ADDENDUM NUMBER: Two (2)

TITLE: Construction Services for Arlington Water Treatment Plant High Service Pump Replacement

JEA IFB NUMBER: 090-17

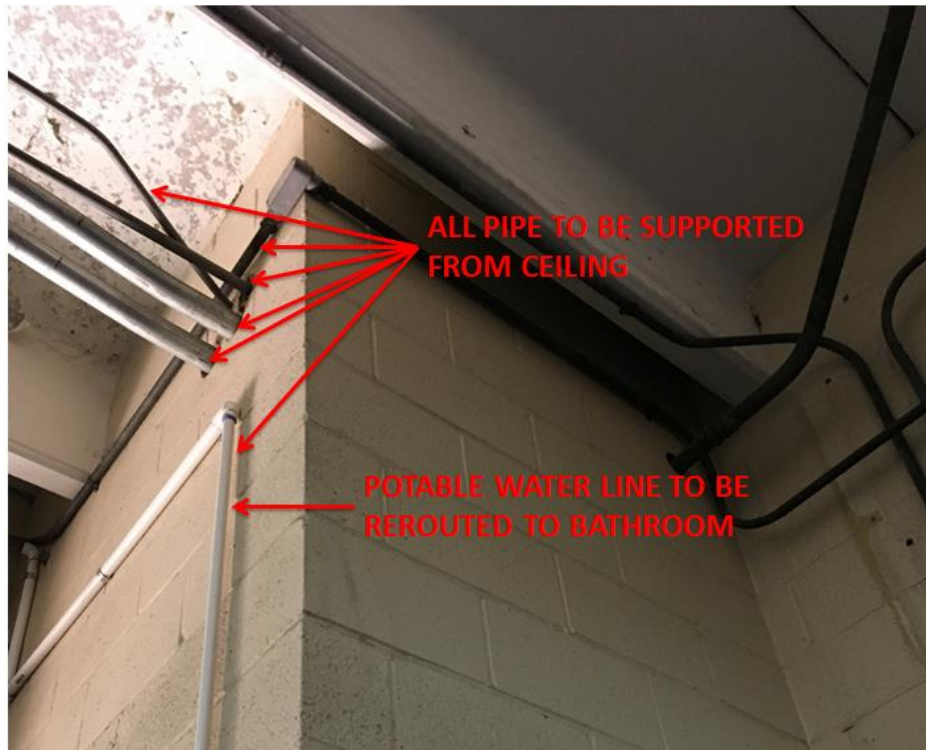
- **RESPONSE:** Contractor shall remove and replace up to 600 SY of roadway base and asphalt per detail M-04.
11. **INQUIRY:** In the existing kitchen area the control panel is shown to be removed and relocated on Drawing M-1, however relocation is not specified. In addition, there appears to be a second panel in conflict with the wall demolition, as well as some existing conduit and pipe attached to the existing wall to be demolished.

- **RESPONSE:** Contractor shall relocate the two existing control panels that are in conflict with the demolition of the existing CMU interior wall. Control panels are to be relocated and place in the location where the existing kitchen cabinets are located (see photo below). All wiring, conduit, mounting hardware and appurtenances are to be included in the bid. Relocation can be done during plant shutdowns as defined in the response to Inquiry #7 herein.
